Access Compliance Report Public Rights-of-Way (Curb Ramps)

Main Street: GERTRUDE_DR Cross Street: MARTHA_ANN_DR Location: SE

ADA ID: RPRK211220142516 Ramp Type: Type 1 - Perpendicular Diagonal Initial Pass/Fail: Pass Overall Compliance: No Severity Score: 0

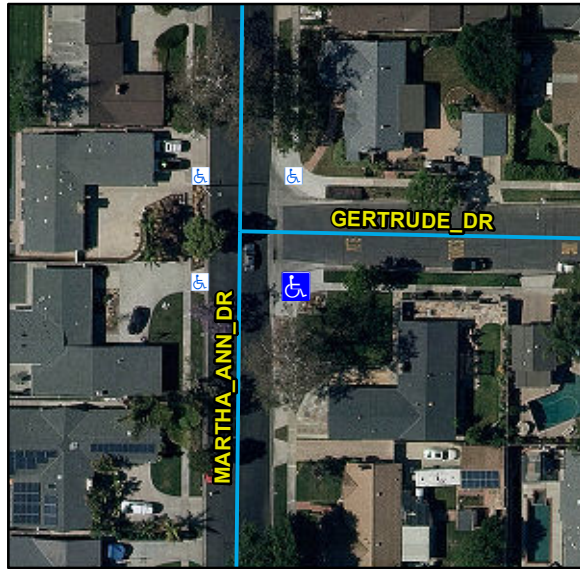
R304.2.2, R304.2.2-Perp, R304.3.2-Para, STD 1115

Remove & Replace Curb Ramp With Two New Directional Ramps or Equivalent.
